Service Bulletin

SEB07-2

ENGINE MOUNT BRACKET INSPECTION

For Model 172 thru 172N, R172K, FP172, F172D thru F172N, and FR172E thru FR172K Airplanes
Figure 1. Engine Mount Bracket Inspection (Sheet 1)

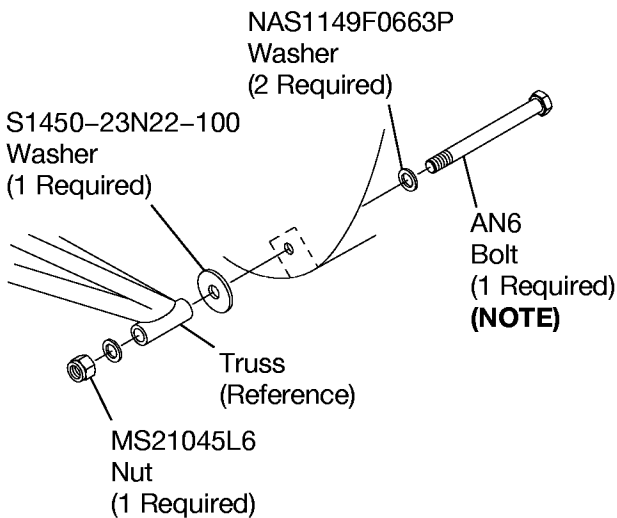
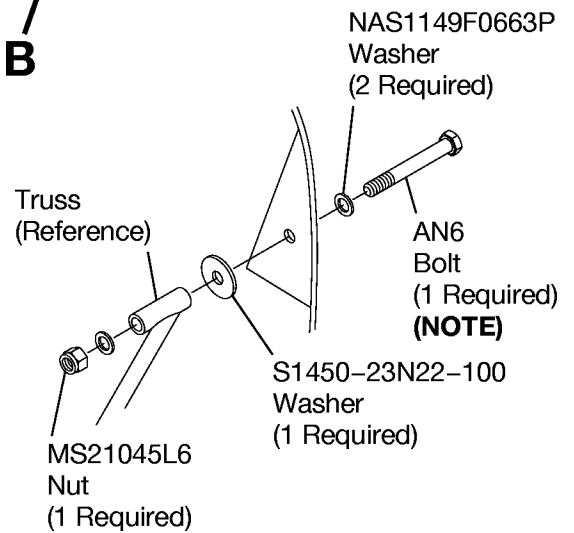
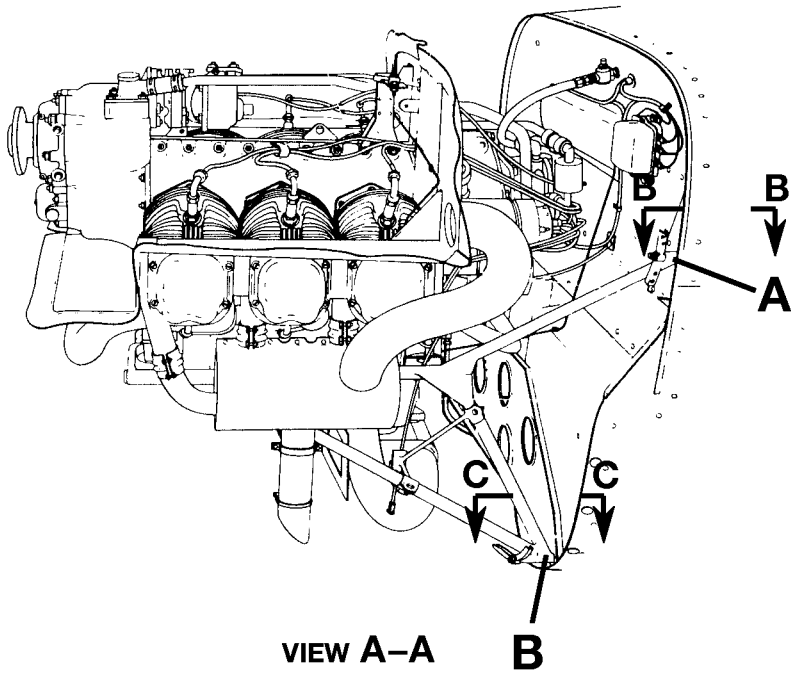
4. Use an engine hoist to remove all of the engine weight from the engine truss.
5. Do an inspection of the left 0513132-11 Upper Mounting Bracket:
 - A. (Refer to Figure 1, View A-A and Detail A.) From a position under the instrument panel, move the wires and the insulation away from the bolt that attaches the upper left engine truss to the left 0513132-11 Upper Mounting Bracket.
 - B. Remove and discard the bolt, washers, and nut that attach the truss to the left 0513132-11 Upper Mounting Bracket.
 - C. (Refer to Figure 1, View B-B.) Put a borescope through the slot in the 0513132-7 Upper Left Stringer.
 - D. (Refer to Figure 1, View D-D.) Look carefully for a deformed or cracked left 0513132-11 Upper Mounting Bracket.
 - (1) If you do find deformities or cracks, go to Step 5E.
 - (2) If you do not find deformities or cracks, go to Step 6.

- E. (Refer to Figure 1, View B-B.) Remove the left 0513132-11 Upper Mounting Bracket from the 0513132-7 Upper Left Stringer and the airplane skin.
 - (1) Remove the two rivets that attach the left 0513132-11 Upper Mounting Bracket to the hat section of the 0513132-7 Upper Left Stringer.

- (9) Apply Alodine to bare metal.
 - (10) Do a touch-up of the paint as necessary.
 - (11) (Refer to Figure 1, Detail A.) With the AN6 Bolt, S1450-23N22-100 Washer, two NAS1149F0663P Washers, and MS21045L6 Nut, attach the upper left engine truss to the left 0513132-11 Upper Mounting Bracket.

- (12) Torque the MS21045L6 Nut to 450 to 500 inch-pounds.
 - (13) Go to Step 6.
- 6. Repeat Step 5 for the right 0513132-11 Upper Mounting Bracket.
 - A. (Refer to Figure 1, Detail A.) For the installation of the upper right engine truss to the right 0513132-11 Upper Mounting Bracket, use the same hardware that is specified in Step 5F(11).

Figure 1. Engine Mount Bracket Inspection (Sheet 2)

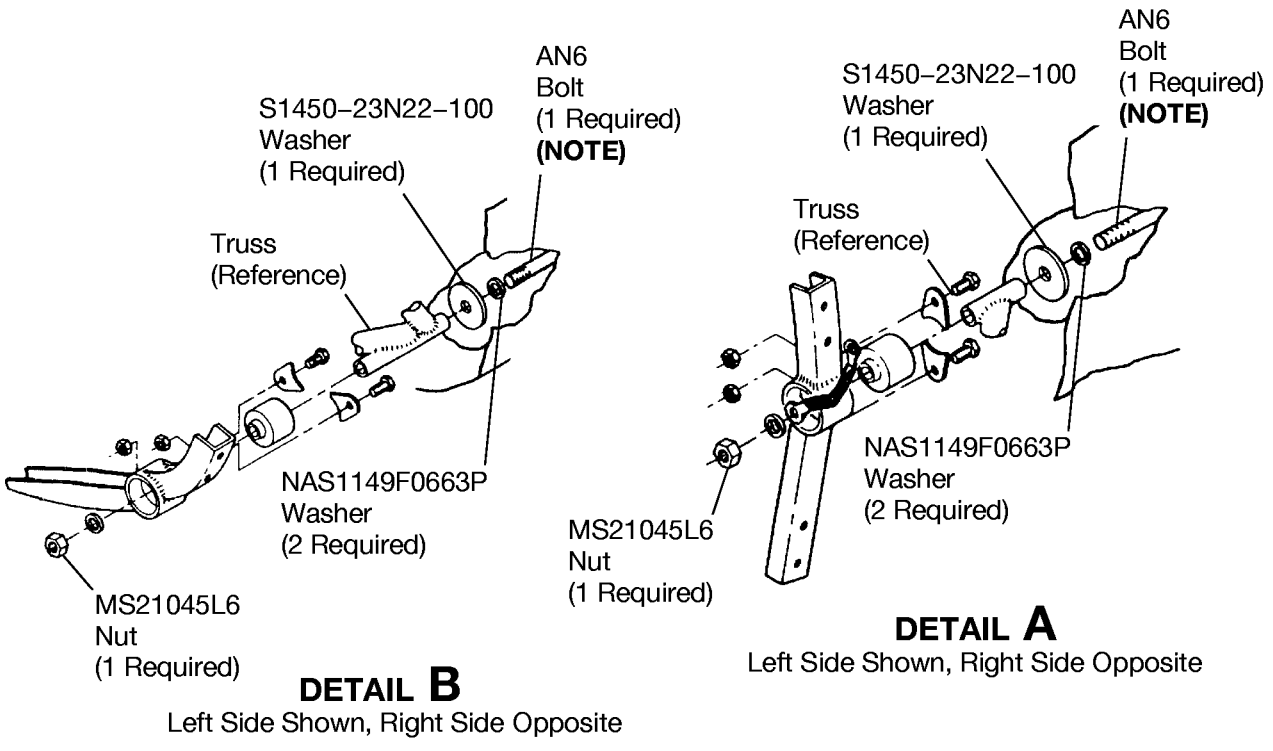
B. (Refer to all applicable details and views in Figure 1.) Do Steps 5B thru 5F again for the 0513132-10 Lower Right Mounting Bracket and the 0514132-9 Lower Left Mounting Bracket as necessary.
